Addendum 02

Project #: 1328-23

MAISD South – Office Renovations
684 Harvey Street
Muskegon, MI 49442

Purpose: Addendum 02

FLOOR PLAN
 1/8" = 1'-0"

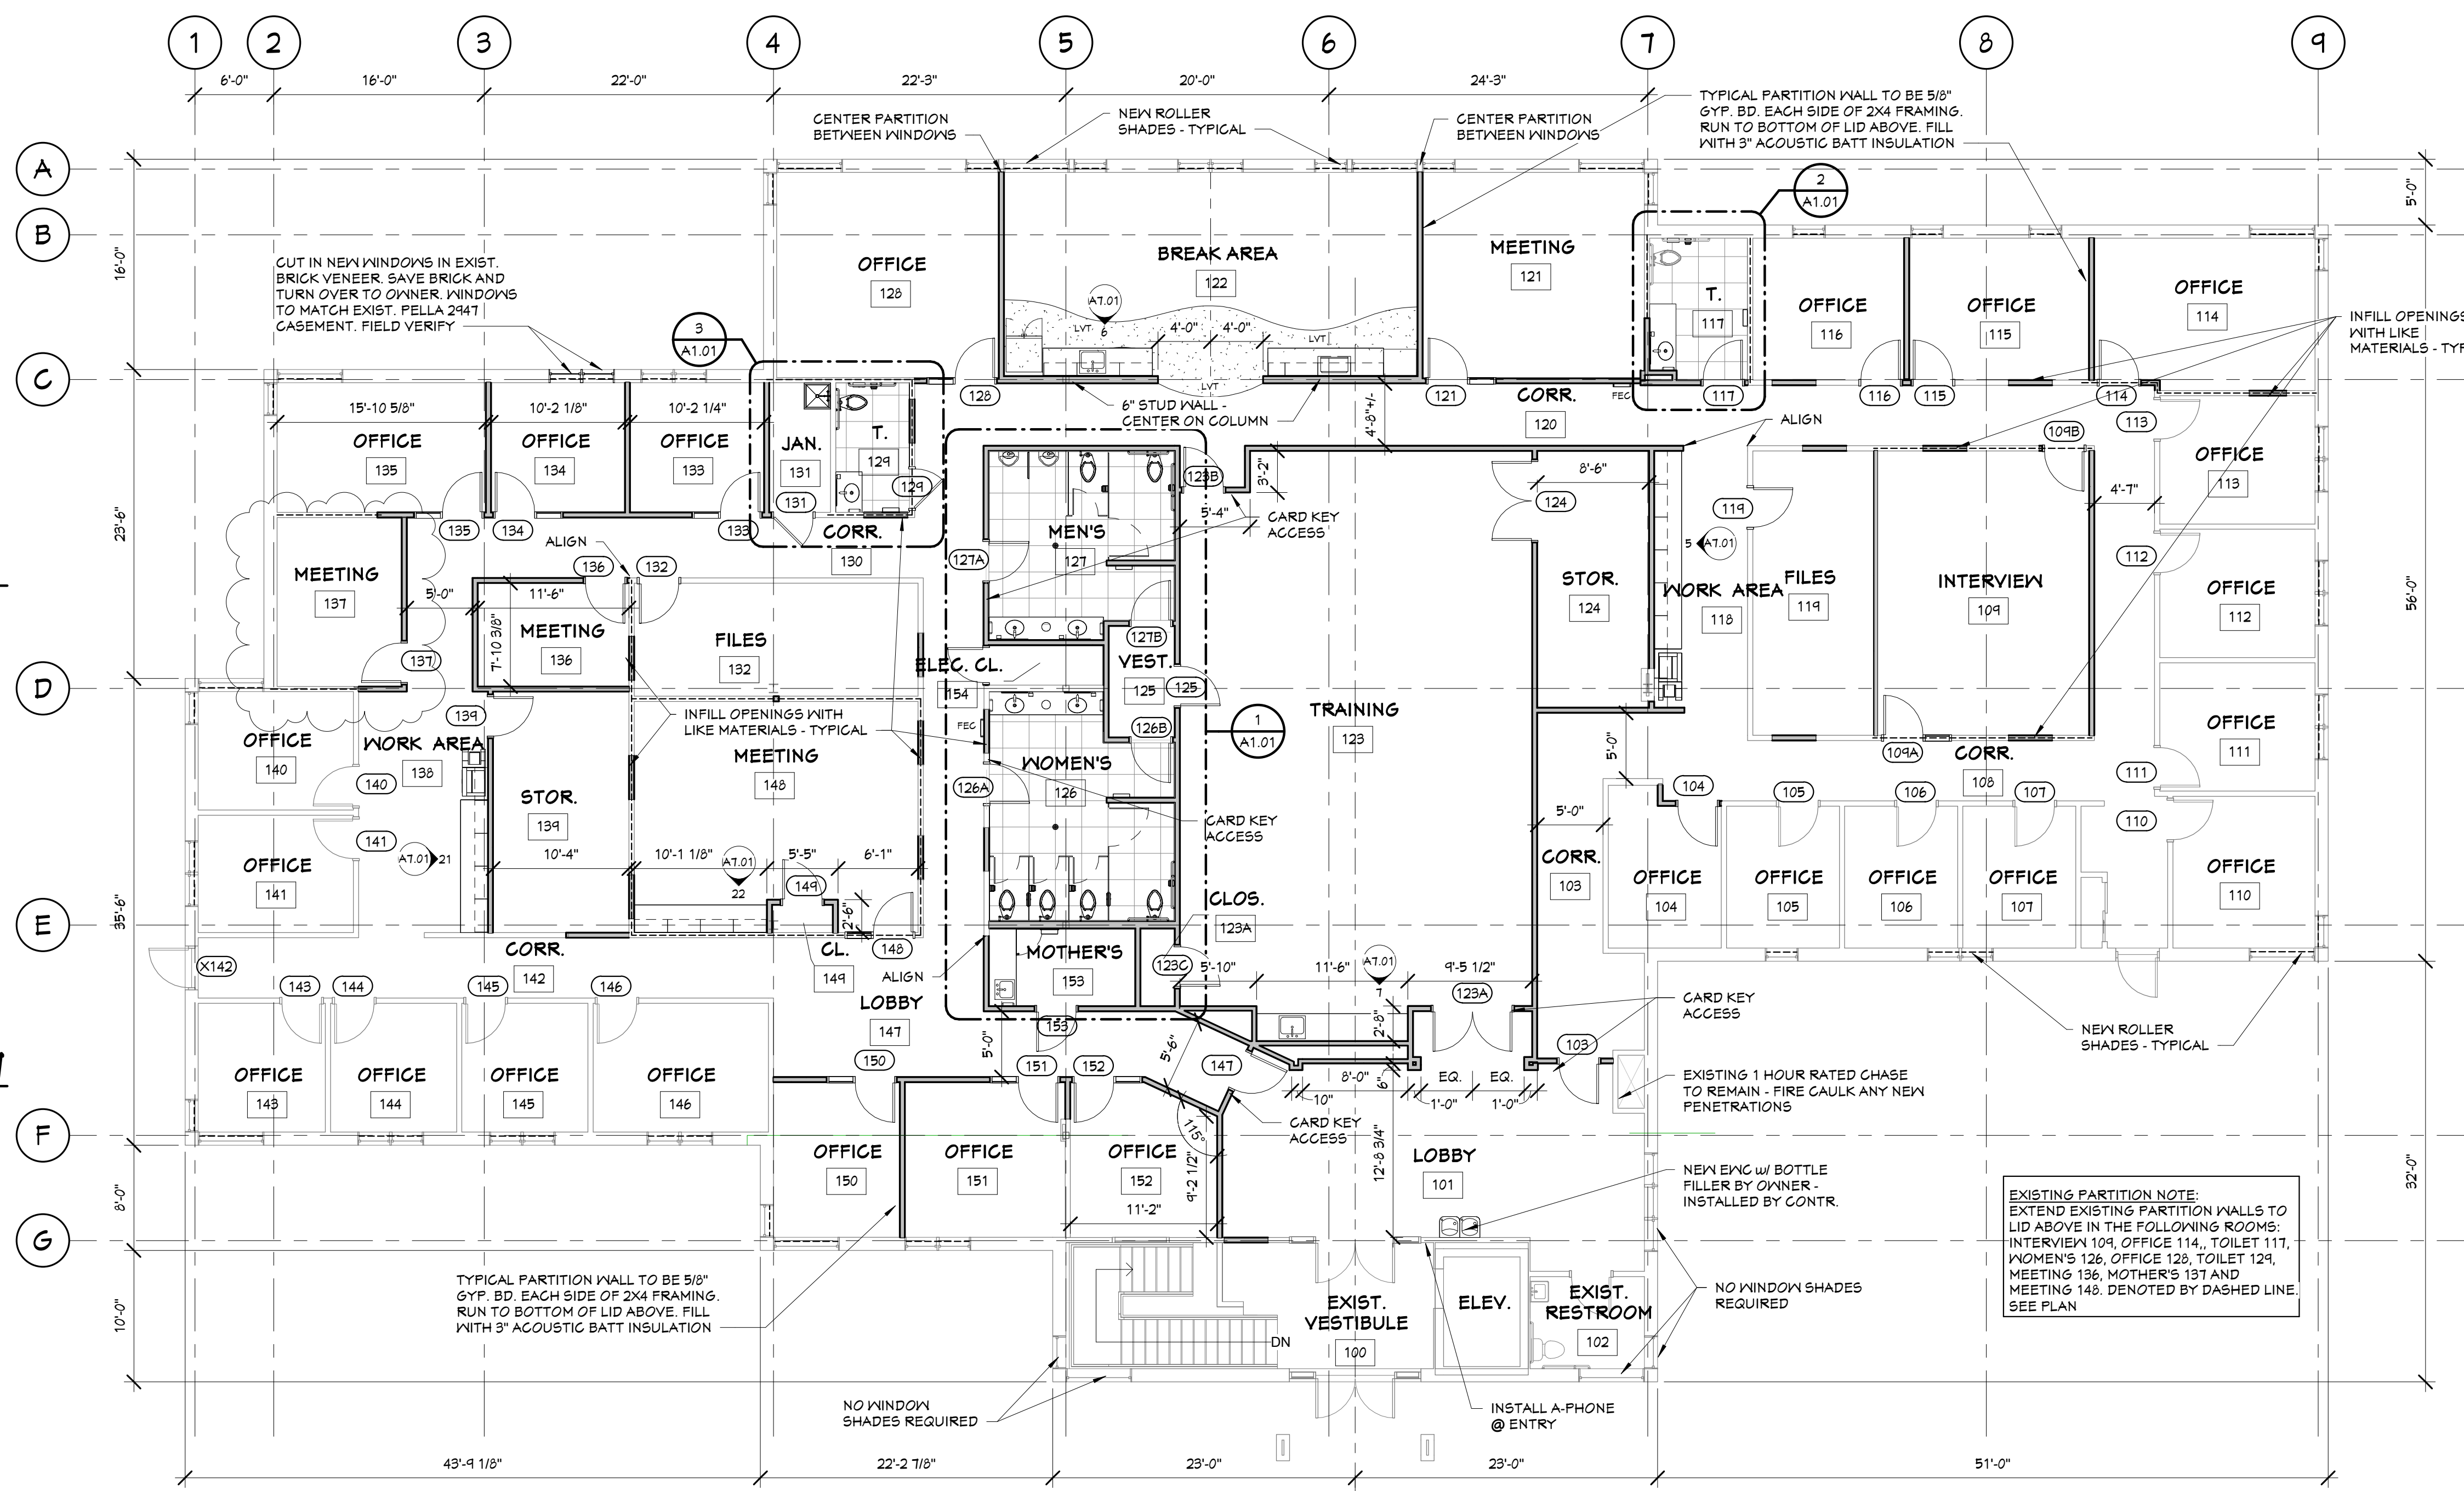
Item #5 LVT – location / Area in Break Area 122 :

See attached Sheet A1.01 for clarification on location of LVT in Break Area 122.
Approx. 120 SF

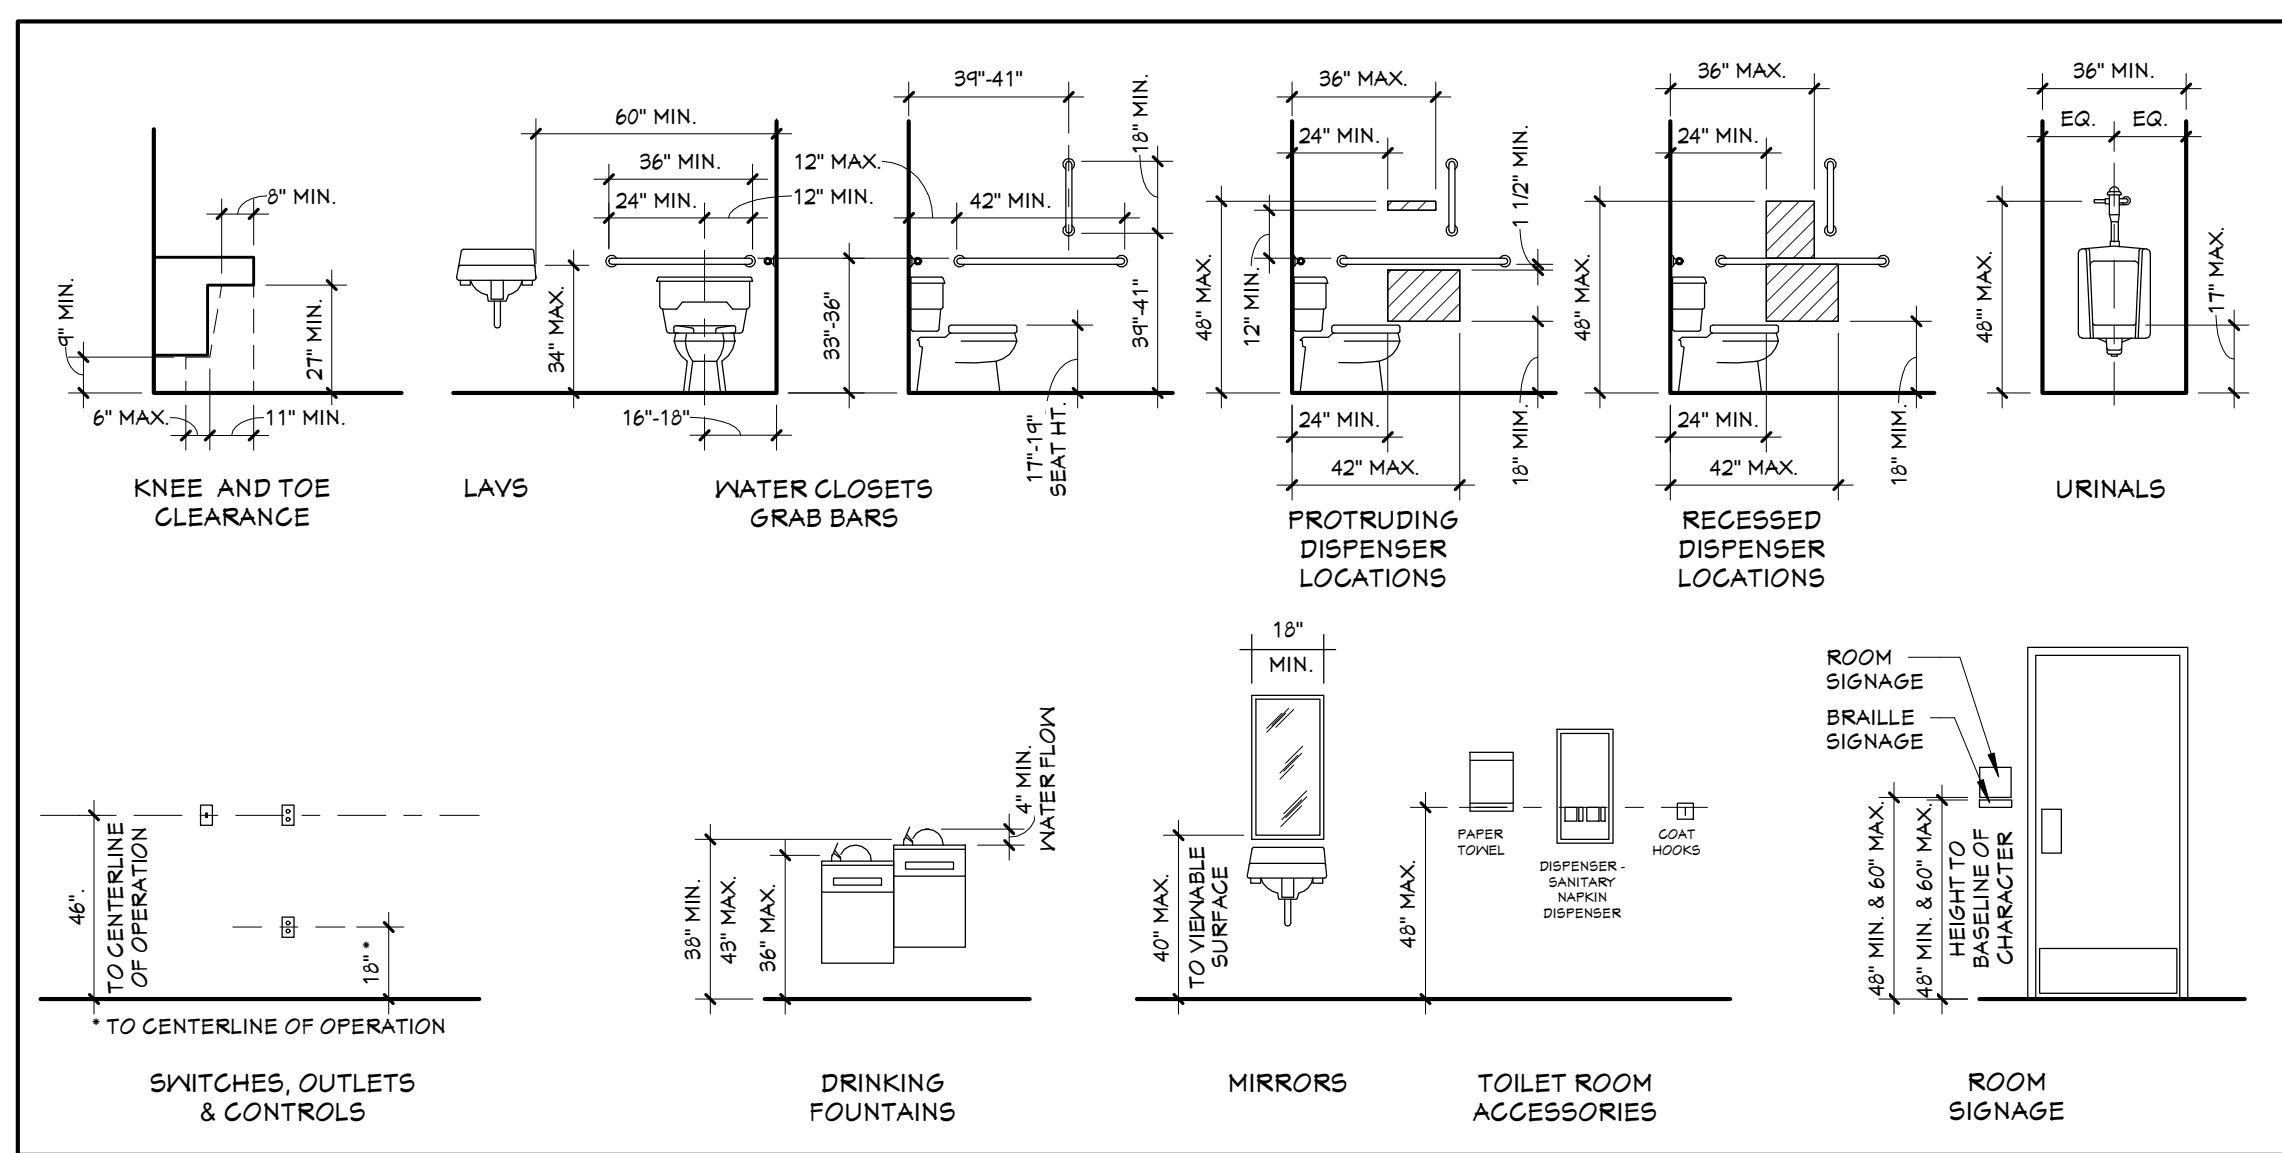
Item #4 Detail 19 Sheet A7.01 Mislabeled :

See attached Sheet A7.01 – Detail #19 was mislabeled. It should read T. 129 – SOUTH.

MECHANICAL PLAN

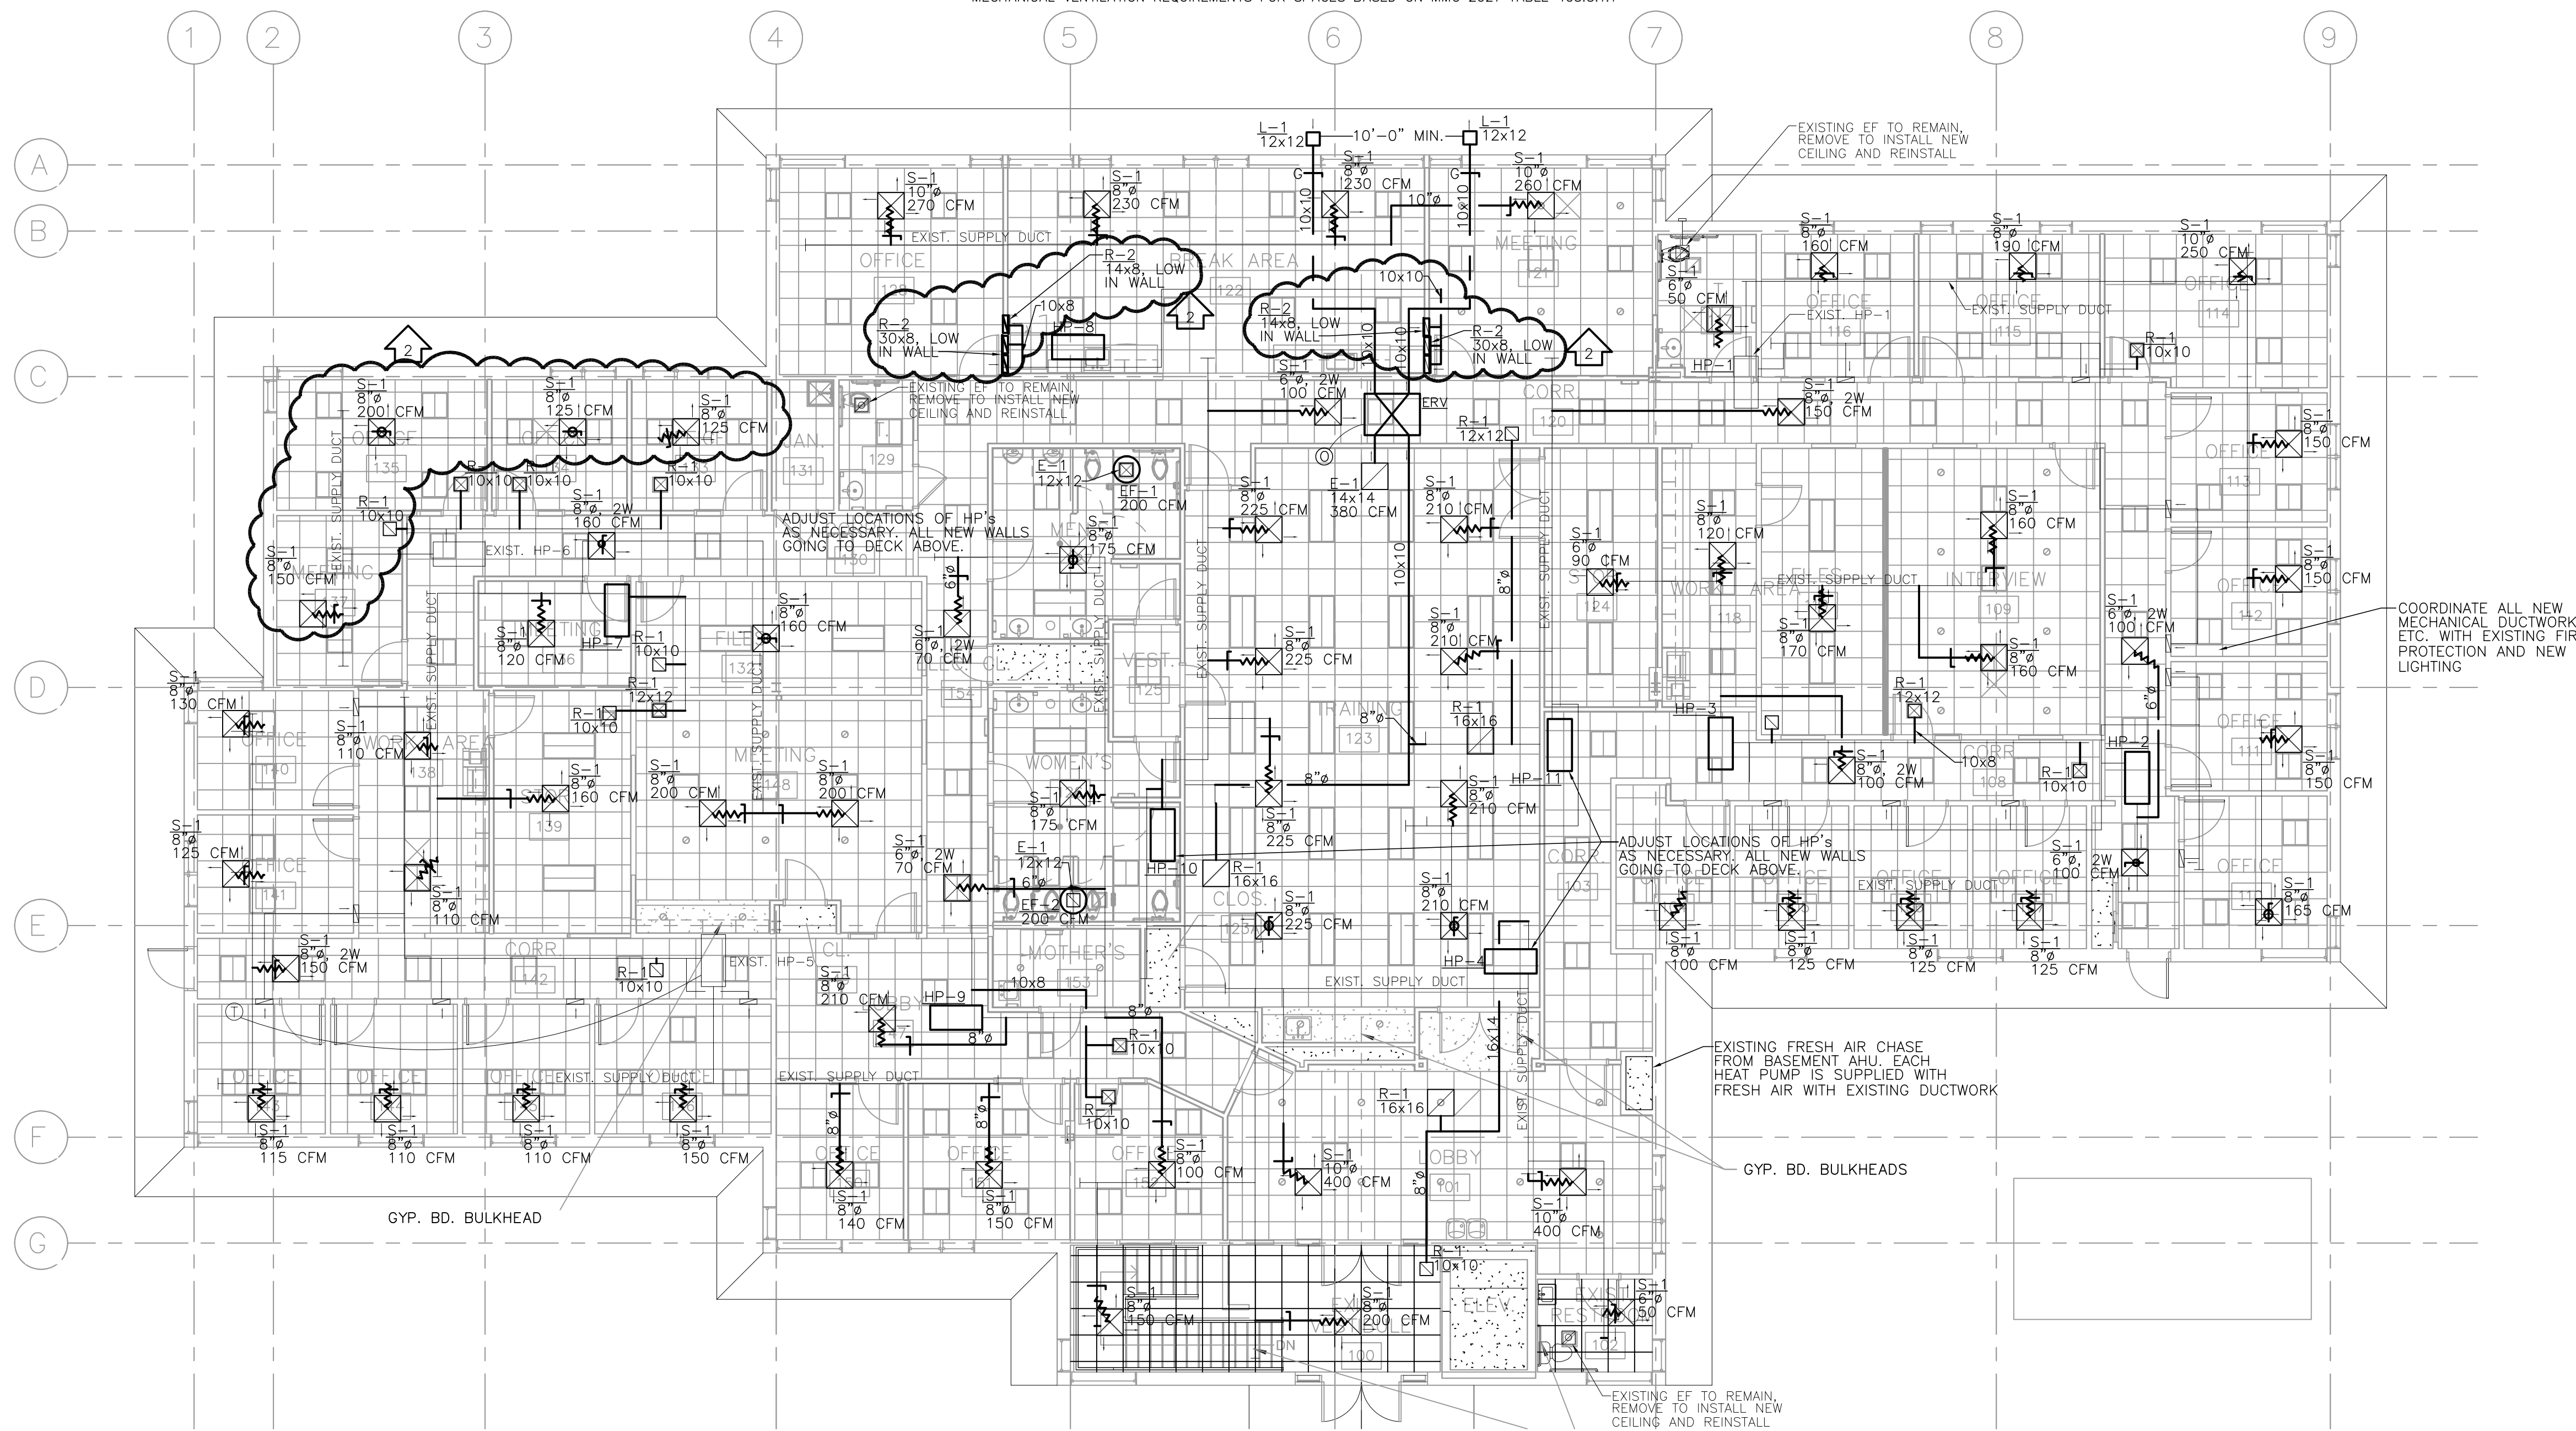
Item #2 Mechanical Clarifications, missing grill designations :

See attached Sheet M1 for missing grill designations, North West corner of plan, bubbled.
